Subject: Submittal of RAI Response Regarding WCAP-8354-P-A & WCAP-8355-A, "Long Term Ice Condenser Containment Code - Lotic Code"

LTR-NRC-17-56 NP-Attachment

RAI Response Regarding WCAP-8354-P-A & WCAP-8355-A,
“Long Term Ice Condenser Containment Code - Lotic Code”

Figure 1 Containment Pressure Comparison

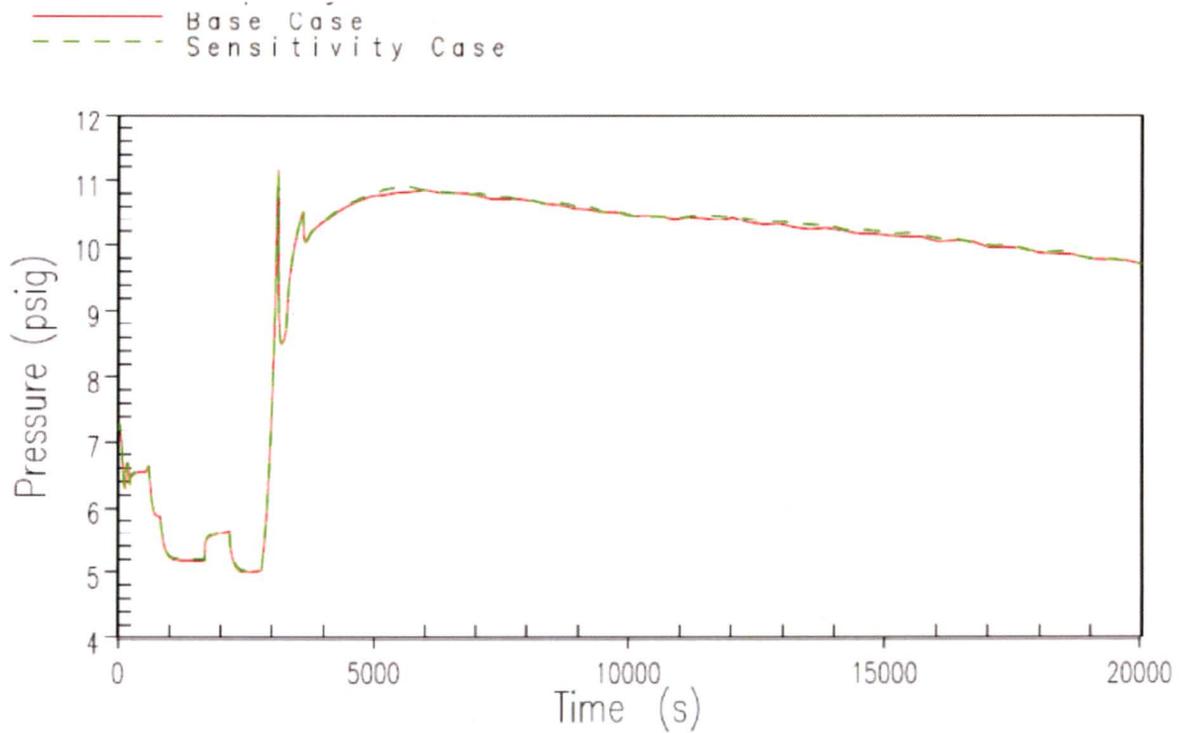
SRXB-RAI 1 – The addition of “ice-empty part of the ice compartment” in [1] appears to be a significant change in the total volume (lower compartment volume + ice-empty volume) which is compared with the expanding volume, because the ice-empty volume varies from zero (or a small volume) to the full volume of the ice-compartment during the depressurization phase. Provide a quantitative impact of this change on the entire pressure response, including the peak pressure, by performing a sensitivity analysis for the most bounding ice-condenser plant in the United States.

The calculated peak pressure from the base case analysis is 11.2053 psig. The calculated peak pressure from the sensitivity case is 11.1966 psig, which is 0.0087 psi lower. A comparison of the transient containment pressure, temperature, and sump temperature results for the two cases is shown in Figures 1 through 4 that follow. Changing how the lower compartment conditions are modeled during the bubble expansion period has a negligible effect on the calculated results.

Figure 4 Sump Temperature Comparison

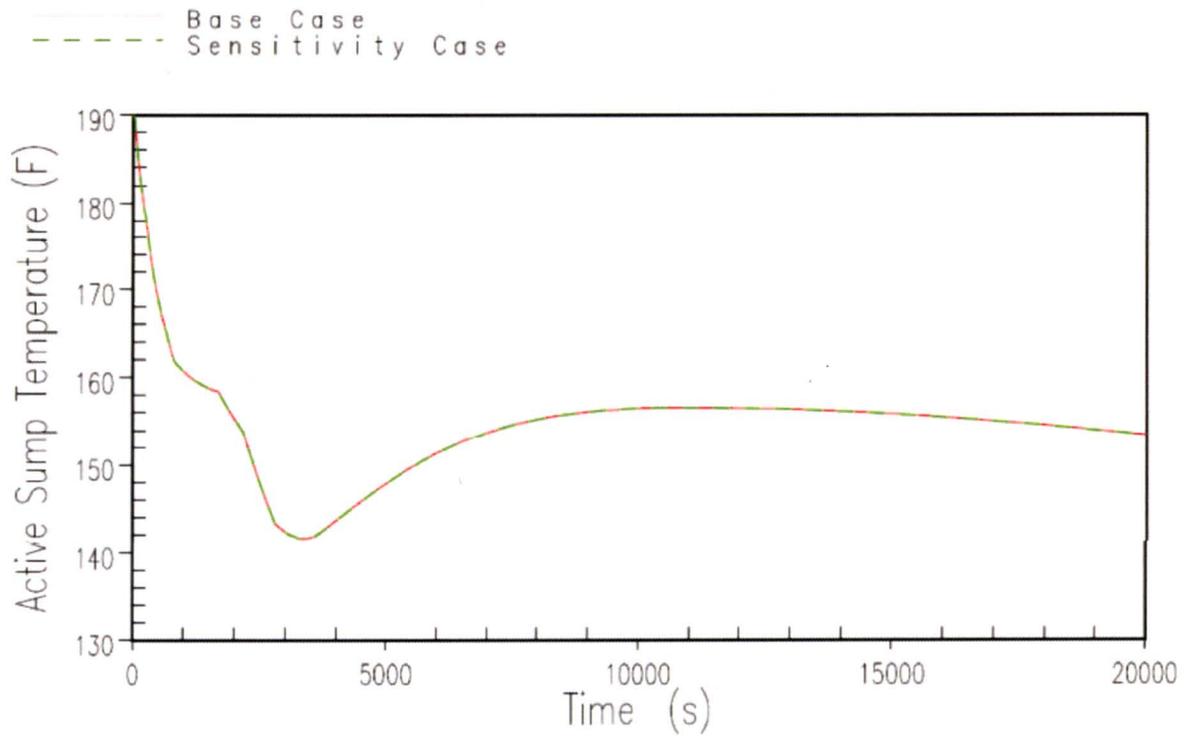
Please state by what method it was determined that the affected portion of the transients (containment pressure, containment temperature, and sump temperature) would have a negligible impact. Provide quantitative results by performing sensitivity study showing negligible effect on the above transients and their peak values for the most bounding ice-condenser plant in the United States.
